Lewis River Fish Passage Subcommittee Meeting

FINAL Meeting Notes
Lewis River License Implementation
ACC Fish Passage Subcommittee Meeting
May 11, 2023
2:30 pm – 4:30 pm
MS Teams Meeting

**Lewis River License Implementation
ACC Fish Passage Subcommittee Meeting
May 11, 2023**

30% Design Layout

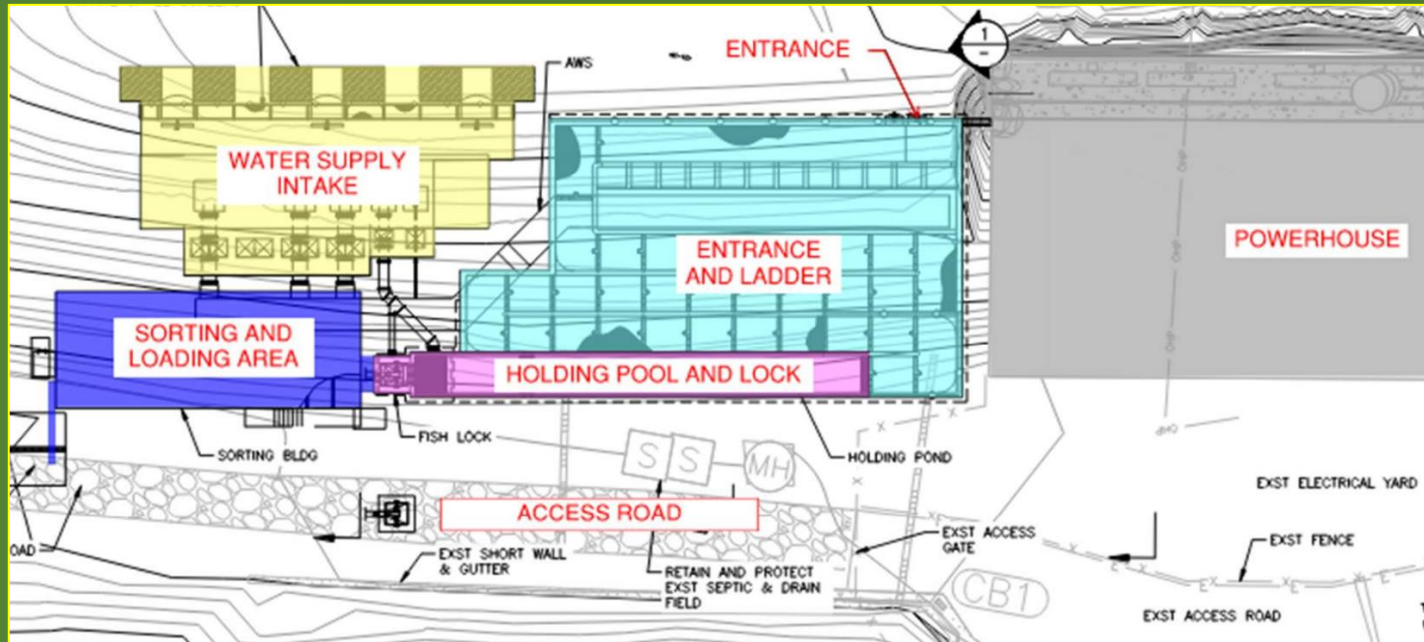
- **Section 9 (Upstream Passage Expansion):** WDFW is interested in capacity. Bryce appreciated the change from six to seven pounds. They are still struggling with the 1,800 fish per cycle as it isn’t in alignment with the information they provided. WDFW will think more about it to see if they are comfortable with that number. They suggest that better clarification of the operational cycle would be helpful. There is some improved language, but some is vague. They haven’t received any feedback on the numbers provided at the last meeting. Todd said there are different ways to get the fish upstream. You can build a super big facility, or you can operate with additional cycles.

Chris appreciated Bryce giving the presentation at the last meeting. He then shared some slides to show what the current design is and how it applies to the WDFW presentation. Regarding “front door” capacity and operational cycle. We can add more trucks to transport more fish. Staffing is anticipated to be limited, but in peak coho season more can be added. Peggy said she was trying to figure out the math of getting to 7.7 hours. Chris said that at Merwin, it typically takes 45 minutes initially to get a fish tank full and ready for transport. While that load is being transported, the second tank is getting readied. Once the truck returns, the second tank is loaded. During coho season there are multiple trucks, and WDFW provides assistance. Steve Manlow, LCFRB, asked about fish behavior and overall capacity. How do the fish use it? This assumes the whole facility can be used as a holding area. At Merwin, Chris said fish go into the ladder and crowder area. We’ve observed that fish enter, ascend, and then descend. You can design certain elements to build into the system that prevent fish from moving back downstream. You can easily use one-way gates that fish have difficult time getting out. This is part of Merwin fish ladder/fish lift modifications that’s scheduled for this summer. They can be used for low density times. Other times in the year, you get so many fish in the system that you want them to be able to hold in the entrance pool and ladder areas. Ladders are good holding areas in high density times. Steve said you can install features to help avoid bottleneck. He thanked Chris for the good explanation. Part of the design, Chris said, is having that control with fish moving in and out of the ladder. Erin Peterson, WDFW,

asked about the logistics of trucking. She said it sounds like when running trucks with the sampling crew, they will have the fish ready about the time the first truck gets back. It seems you would need to have a second crew to run a second truck. Chris replied that it boils down to how far they need to go. What they do at Merwin with large numbers of fish is they have multiple tanks where fish can be placed while waiting for transport. In that case where you have the need for additional trucks, is have the crew show up earlier and have two or three tanks ready to go, then load up on top of each other. They do have separate crews (biologists to sort and get tanks ready; another crew is basically the truck drivers). Erin mentioned staffing capacity at multiple dams and was it built in for the other dams? Chris said it will be interesting to see. We already have on-call staffing if need be. We have fish run projections and know how many fish we took downstream, and we can get ready for large numbers of fish years in advance. It's all part of adaptive management as we move forward. Todd said that in our budget planning, we have additional fulltime staff coming in 2026. We'll use contractors to hit the peak if need be. Josua Holowatz, WDFW, asked about monitoring fish movement into the facility, and in the ladder holding area. There is quite a bit of space there – will there be an ability count fish before working them up? Chris said we'll generally know they are coming because we are monitoring and transporting fish at Merwin. There will be accommodations for extra staff. He thinks there is a lot of opportunity to monitor fish progress. Chris to Bryce – are you feeling more comfortable as to where the 1,800 fish number came from? Bryce appreciated Chris's explanation and slides. Todd will add a bit more to Section 9 in the draft Elements document based on Chris's presentation.

- Average fish size: 7lbs/fish
- Total capacity in the entrance pool = 1,829 fish
- Fish ladder = 117 fish per ladder pool (~27 ladder pools):
 - Total capacity in the ladder = 3,167 fish
- Holding pool capacity = 1,100 fish
- Total capacity from entrance to upstream end holding pool ("front door") = 6,096 fish

Yale DS FSC_ Prior Swift FSC Launch Photos Circa 2012

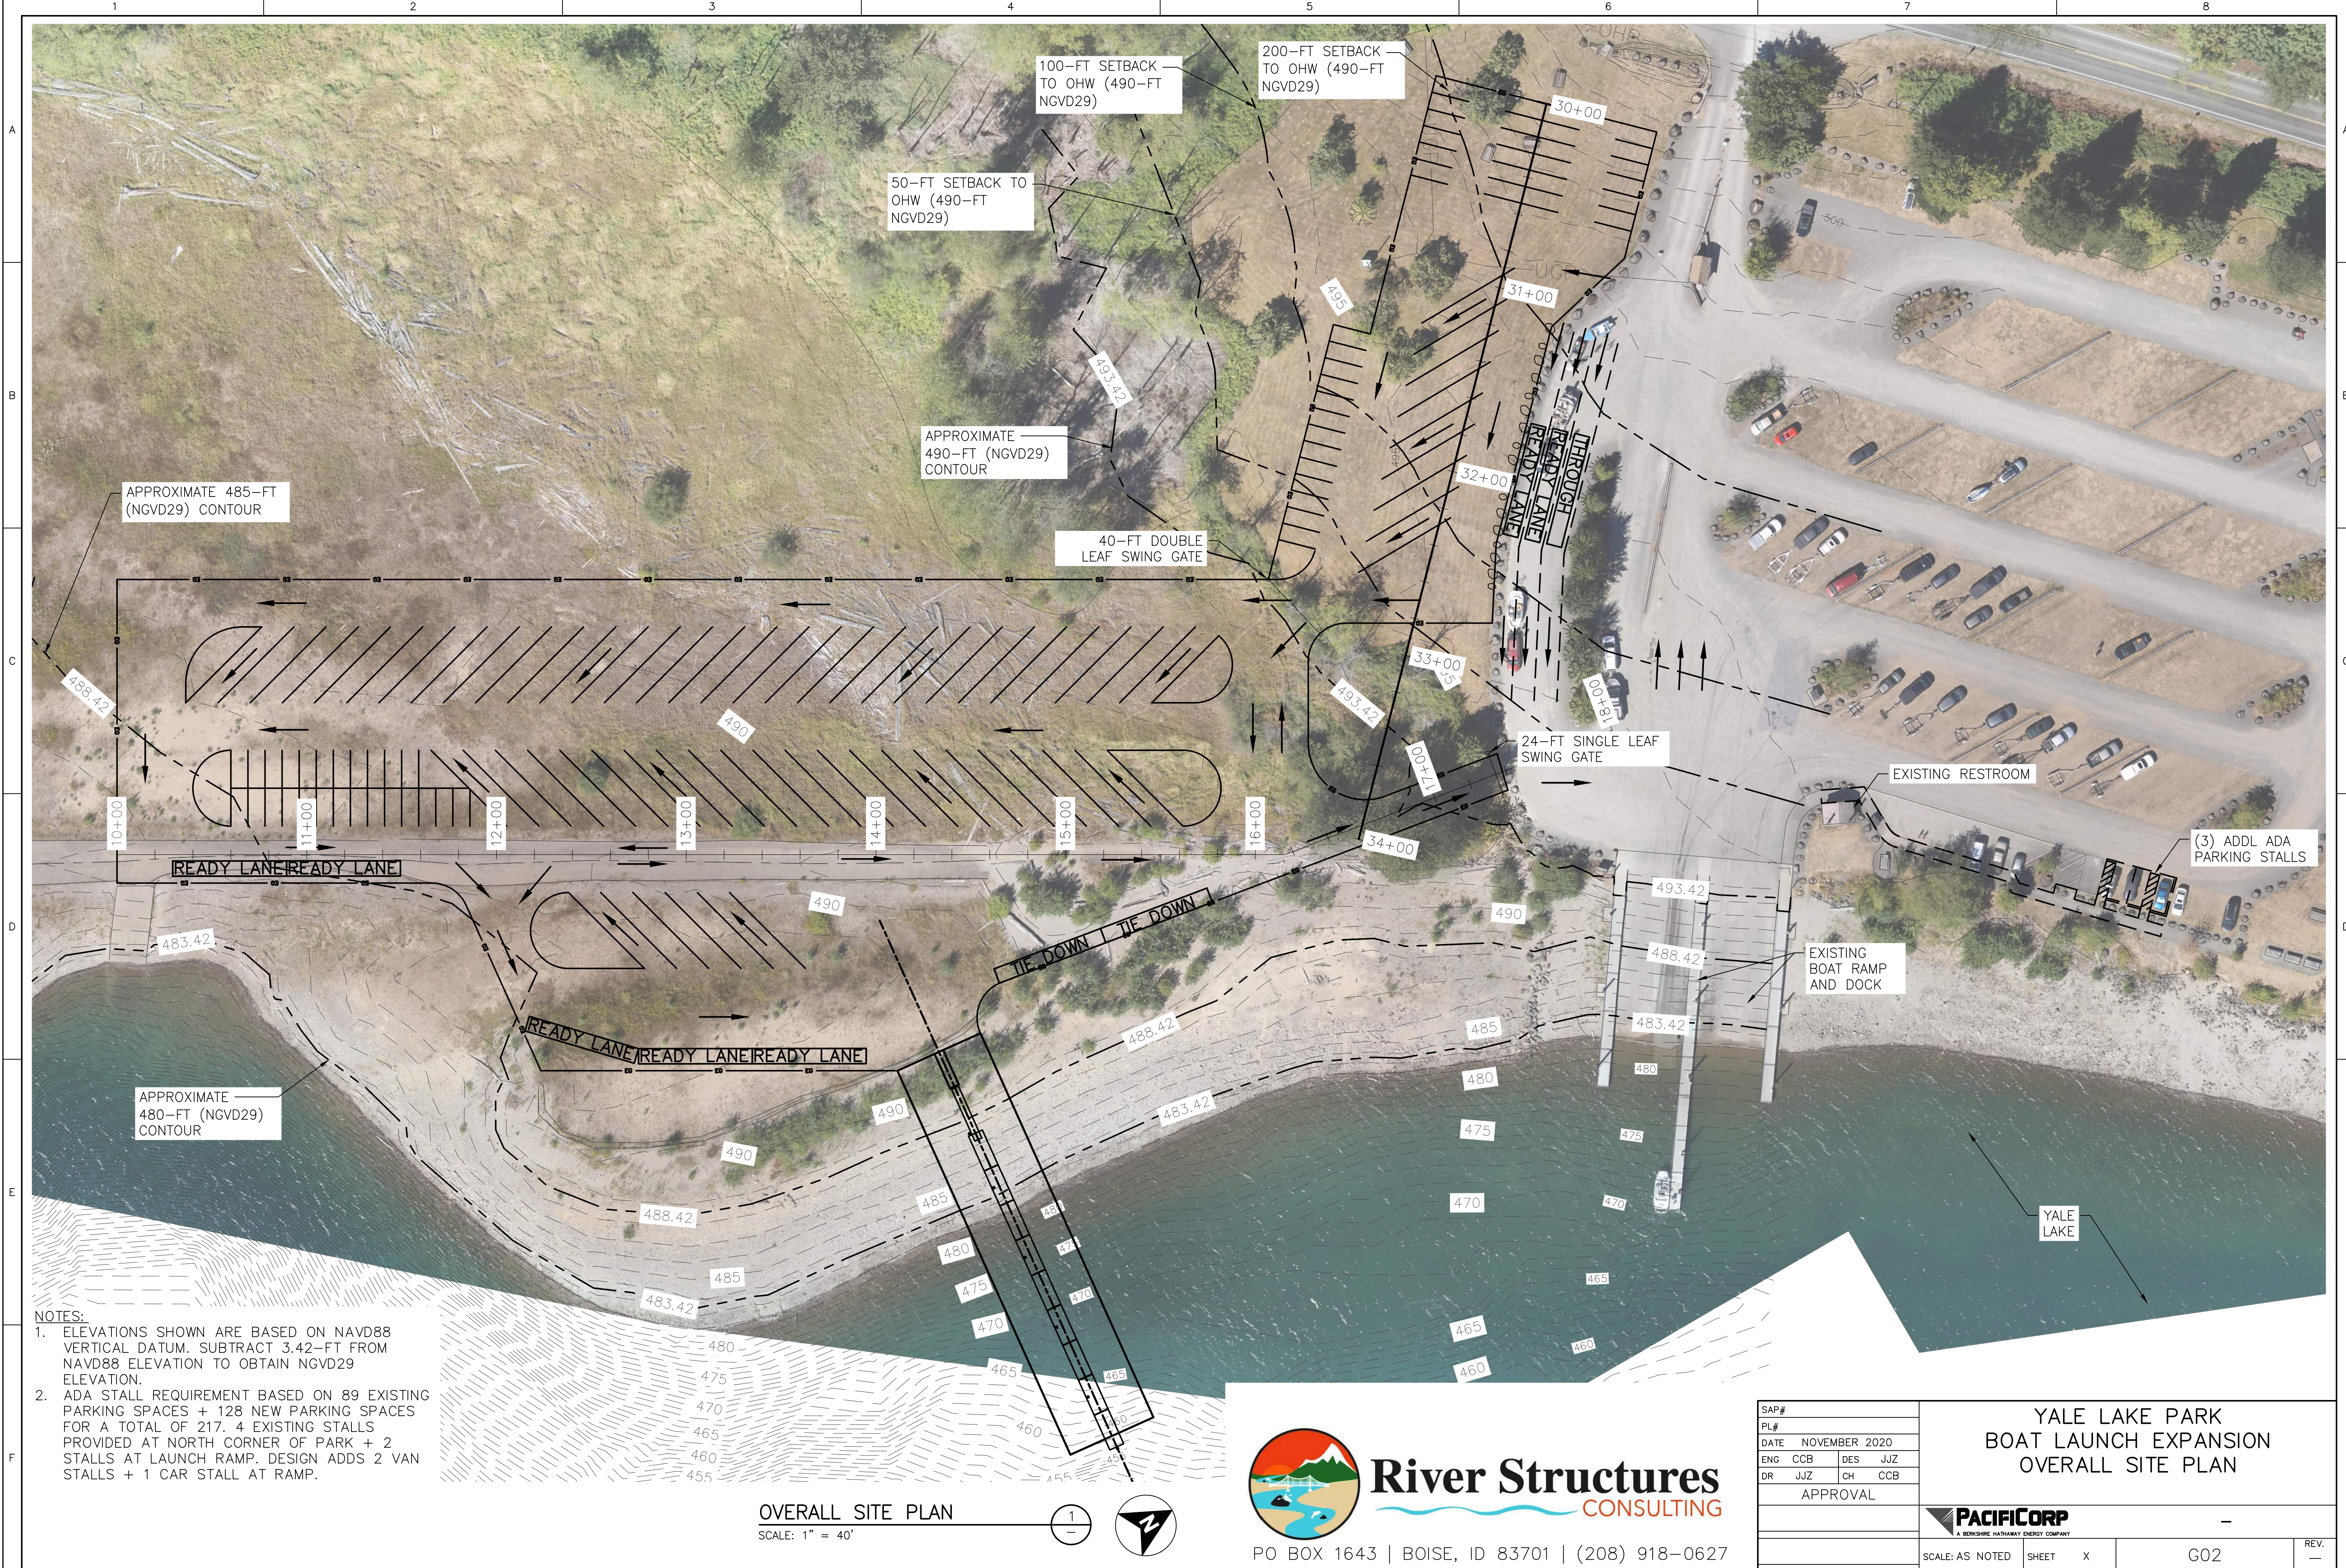
Eric Hansen shared the photo below as an accompaniment to his Yale Downstream FSC, Yale Park, FSC launching site option that he shared during yesterday's FPS meeting. He says, "the photo is an example from the Swift FSC launch site about a decade ago. Literally need a work area the size of the football field to perform this fabrication work prior to launching the FSC into the reservoir."

OVERALL SITE PLAN
SCALE: 1" = 40'

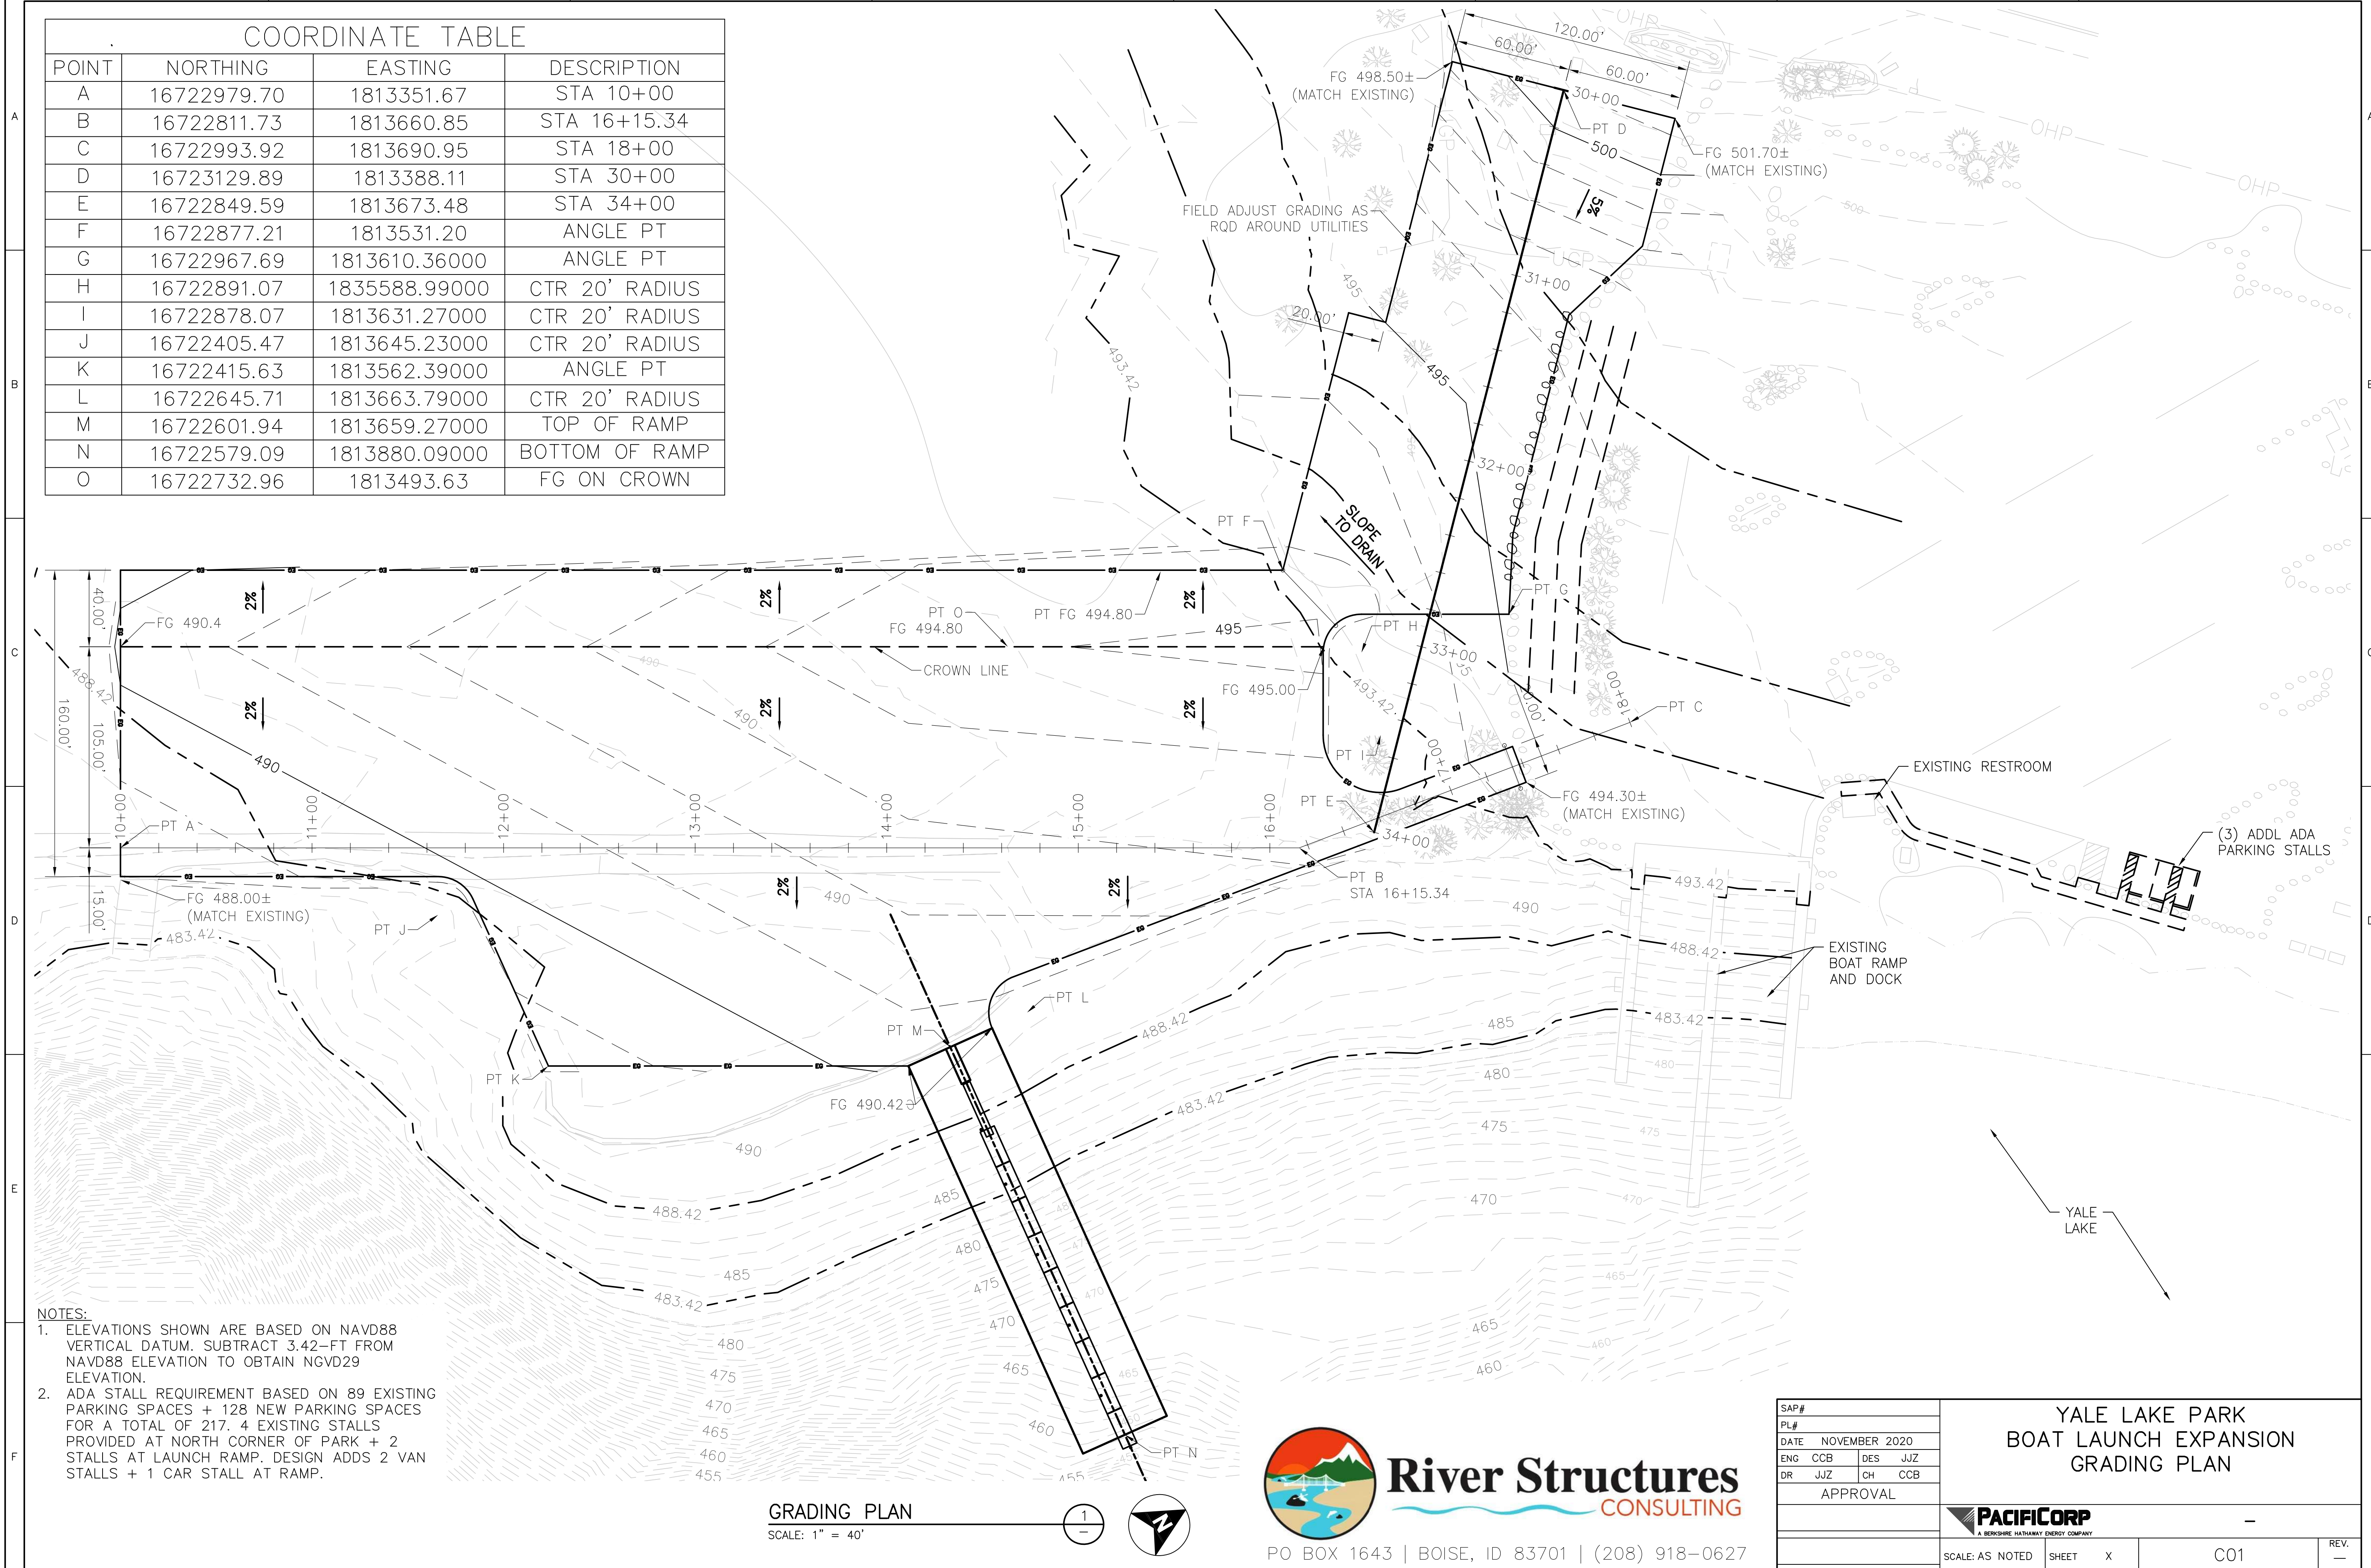
Eric Hansen, PacifiCorp, provided an update on the Yale downstream fish passage facility. He walked the group through an alternative Yale FSC launching locations drawing. The initial location was Saddle Dam; however, the new alternative location is the grassy area at Yale Park where the old boat launch ramp was from the 1980s. He suggested opening the site up and adding gravel to the area so we can build the (FSC, launch it with the new launch ramp as shown and then perhaps turn it into parking and recreational use. At the end of the day, there would potentially be two ramps and a parking area. Bryce Glaser, WDFW, asked about the normal process for recreational use expansion - does it cross ACC and TCC coordination? Todd Olson, PacifiCorp, said it depends on where the park is located. In the case of Yale Park, we would advise the TCC. As we go about these projects, we would be looking at noise impacts and impacts to WHMP land (if any). This project has the potential with such a large work area. Saddle Dam Park is too narrow an area for all the Saddle Dam rehabilitation work going on. We have FERC approval to expand the Yale parking area near the orchards. Eric requested FPS provide any feedback on constructing the FSC at Yale Park.

Bryce likes working towards dual use. He asked two questions: 1) Is this an appropriate area for the FSC and launching? and 2) Is it worth developing it into recreational use? The first question would more pertain to this group. How do we get feedback to you? Todd said provide feedback directly to Todd or Eric and that once we get feedback, we'll have a recreation advisory meeting in the fall and we'll make sure to get this on their agenda. Peggy Miller, WDFW, asked if it is wildlife mitigation land. Todd replied that he would check with Kendel Emmerson, PacifiCorp, on the boundary.

Bryce said in terms of timeline, maybe give folks time to get comments back by the next meeting. Todd said feedback then is fine, we'd like to get input as we work on the 60% design. Next steps: provide questions or concerns about using the proposed site by the next meeting.
